HISTORIC AND DESIGN REVIEW COMMISSION

September 18, 2019

HDRC CASE NO:	2019-456
COMMON NAME:	1211 E Commerce
ZONING:	D
CITY COUNCIL DIST.:	2
APPLICANT:	Paul Kahlich/MCS Architects, LLC
OWNER:	Raju Bhagat/Kennedy Hotel, LP
TYPE OF WORK:	Construction of a 4-story hotel
APPLICATION RECEIVED:	August 06, 2019
60-DAY REVIEW:	October 05, 2019
CASE MANAGER:	Edward Hall

FENESTRATION PATTERN RECOMMENDED BY STAFF

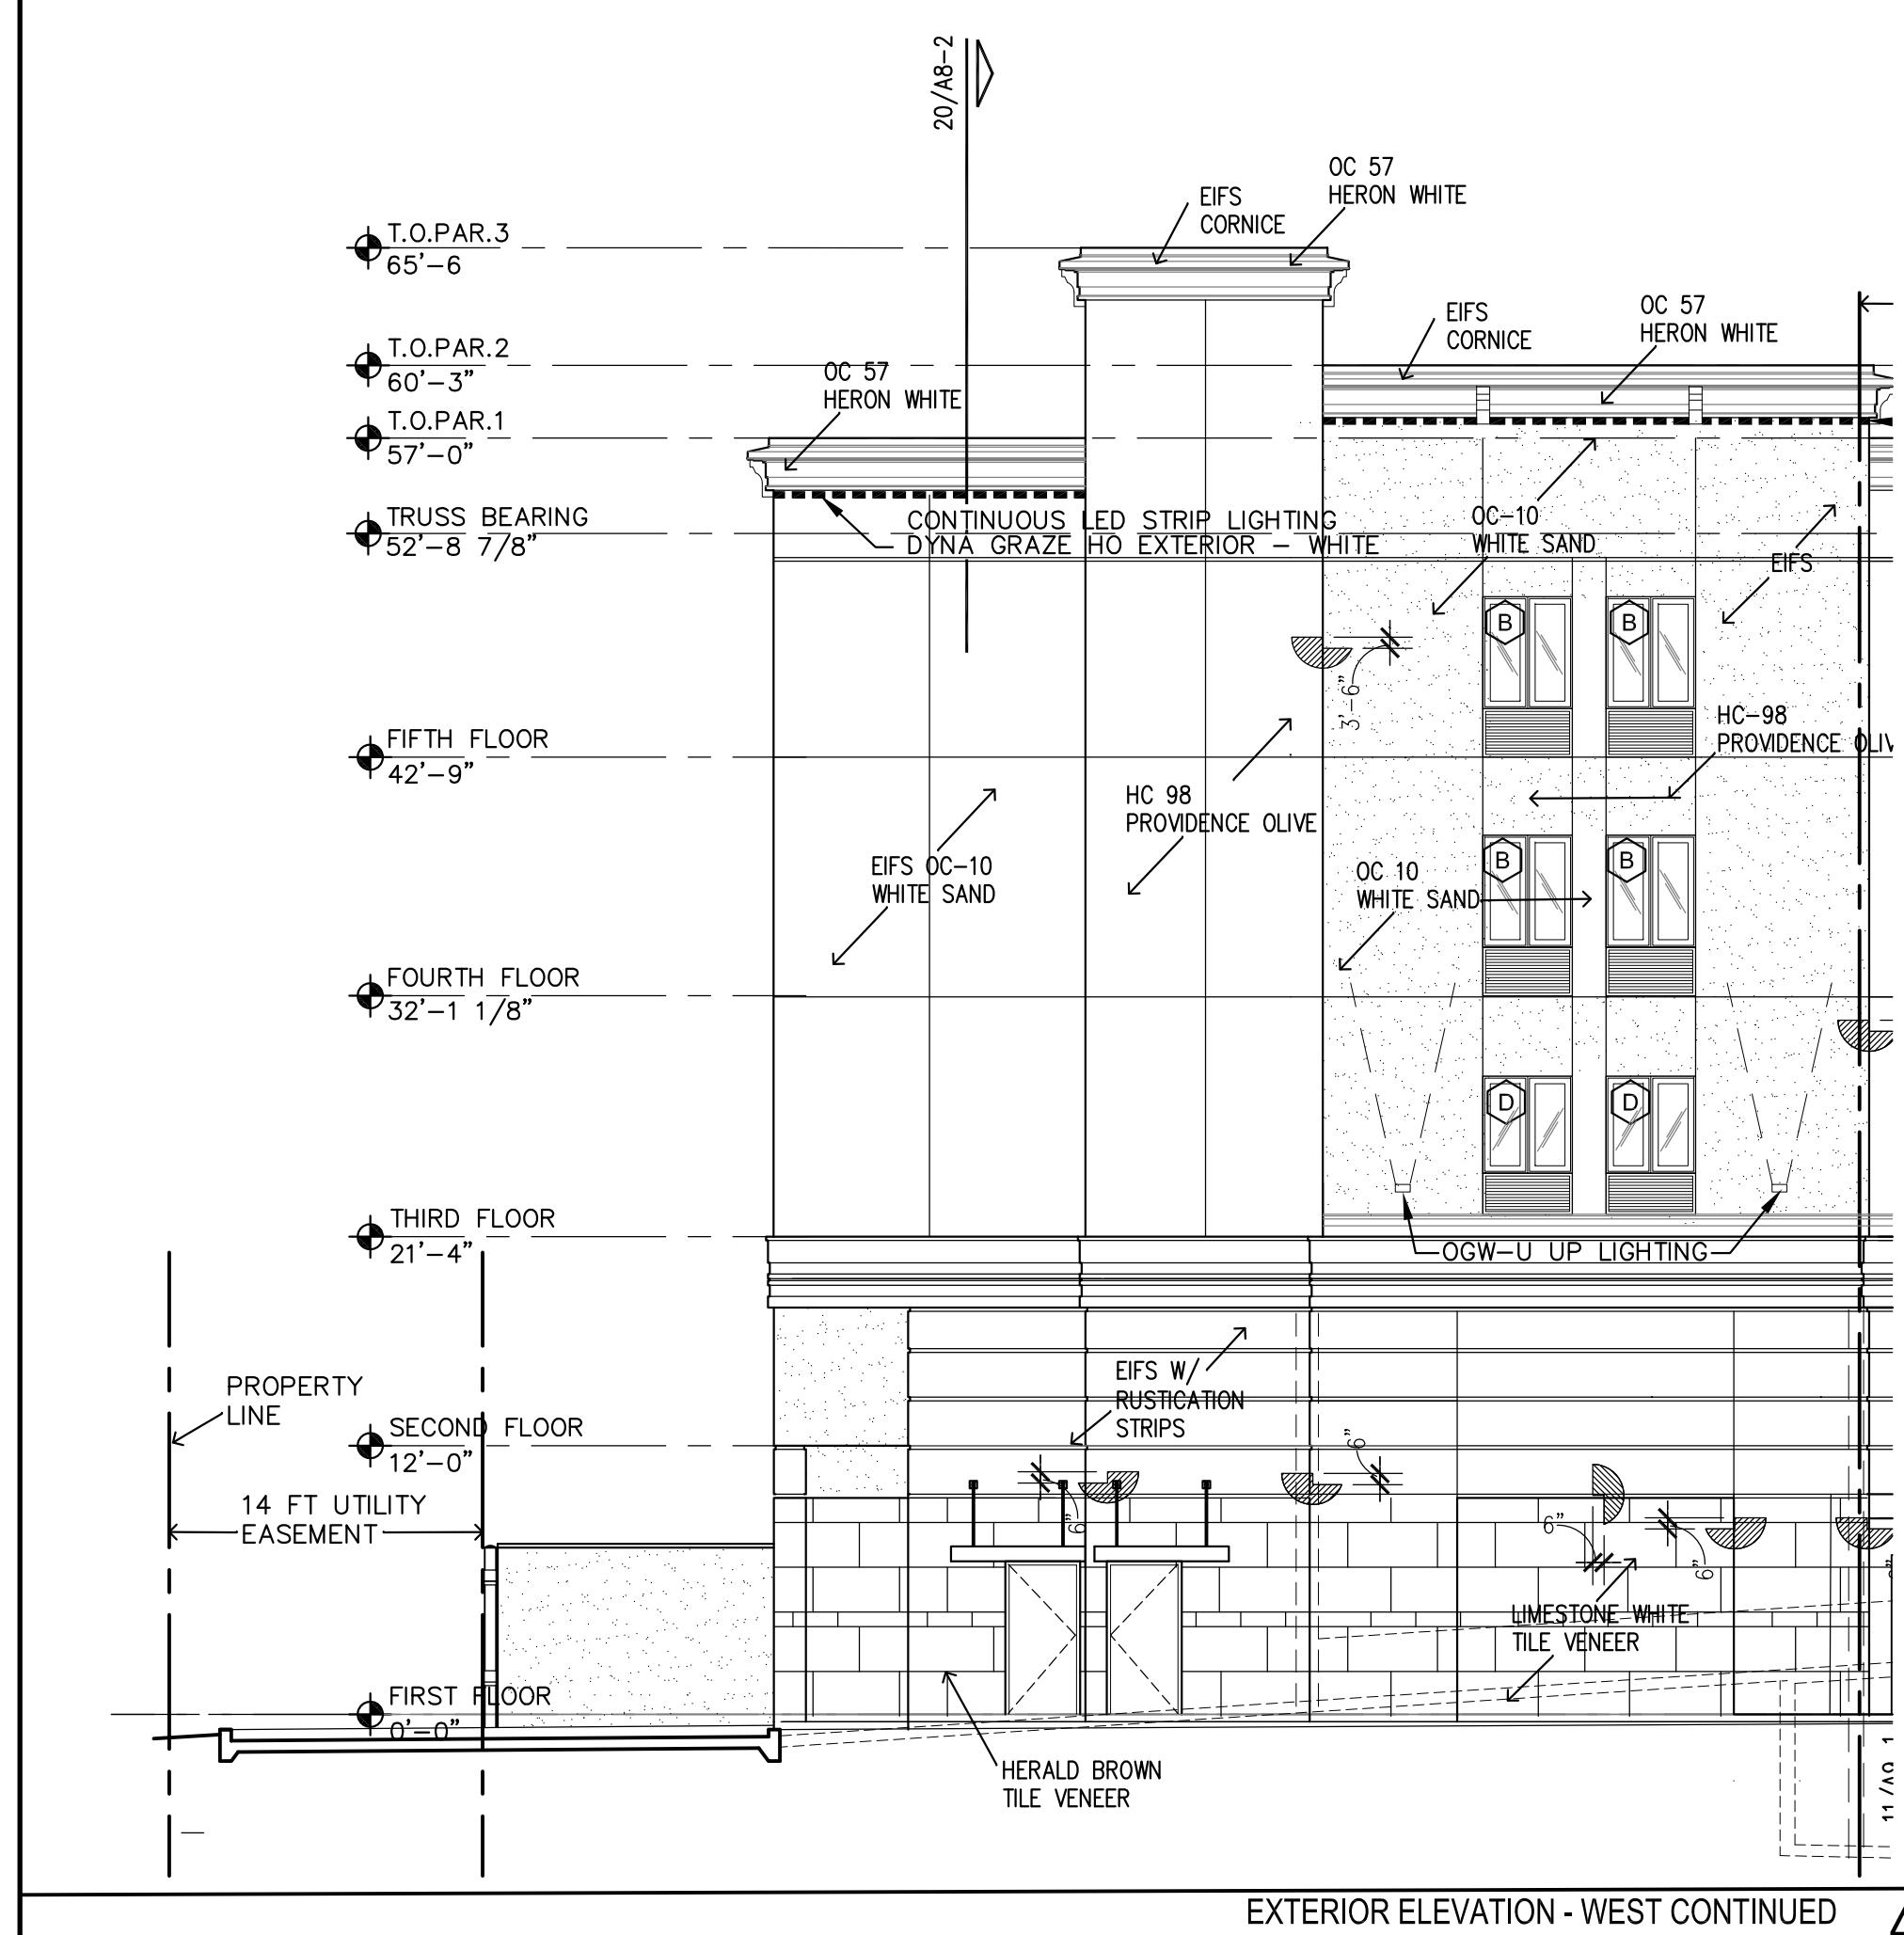
- i. FENESTRATION – The applicant has proposed additional façade separation on the south façade; however, fenestration has not been included. The applicant has proposed recessed façade panels that mimic window openings. Staff finds this to be inappropriate, and finds that actual windows that are recessed two (2) inches be installed at each location. Not only would this introduce more depth and dimension to the street façade, but it would also relate the proposed new construction to the adjacent historic structure.

- ii. That the south elevation feature windows rather than recessed façade panels as noted in finding i. Staff has labeled the recommended elevation within the exhibit file.
